Title - Sujet DARTMOUTH LABORATORY	
Solicitation No. - N° de l'invitation 39903-130355/A	Amendment No. - N° modif. 001
Client Reference No. - N° de référence du client 39903-13-0355	Date 2013-01-23
GETS Reference No. - N° de référence de SEAG PW-\$PWA-121-4958	
File No. - N° de dossier PWA-2-68112 (121)	CCC No./N° CCC - FMS No./N° VME
Solicitation Closes - L'invitation prend fin at - à 02:00 PM on - le 2013-01-29	Time Zone Fuseau horaire Atlantic Standard Time AST
F.O.B. - F.A.B. Plant-Usine: <input type="checkbox"/> Destination: <input checked="" type="checkbox"/> Other-Autre: <input type="checkbox"/>	
Address Enquiries to: - Adresser toutes questions à: Russell, Alex	Buyer Id - Id de l'acheteur pwa121
Telephone No. - N° de téléphone (902) 496-5168 ()	FAX No. - N° de FAX (902) 496-5016
Destination - of Goods, Services, and Construction: Destination - des biens, services et construction:

Amendment 001 is raised for the following Q&As:

Typical DD Box Control

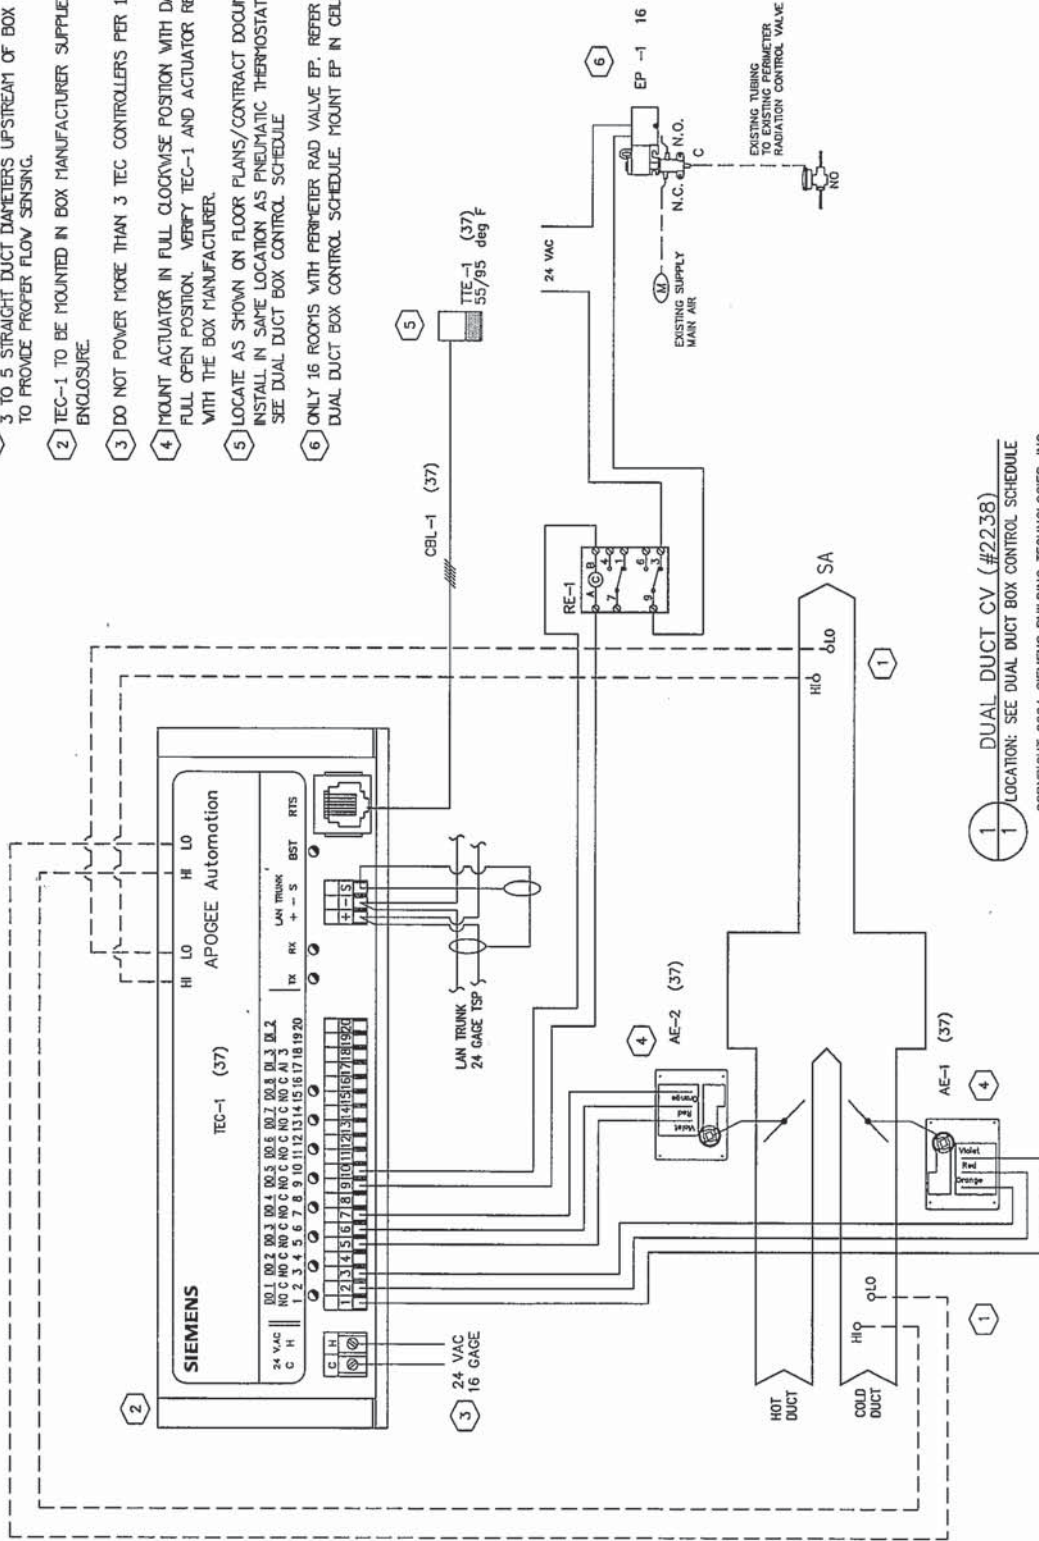
Question 3A: We are just looking for the specifications on the Air valves (need to know the sizes) if you could provide.

Question 3B: "I also mentioned shop drawings on the air valves....we need to know if they are being replaced for the fume hoods and will need the specifications."

Response 3: Air Valves are not to be replaced as part of this contract. Reference attached AIR VALVE LIST for list of installed equipment and sizes. Also included for reference are the AS BUILT SIEMENS DWGS detailing a recent project for replacement of air valves and dual duct boxes. These attachments to be added to Appendix G of contract documents.
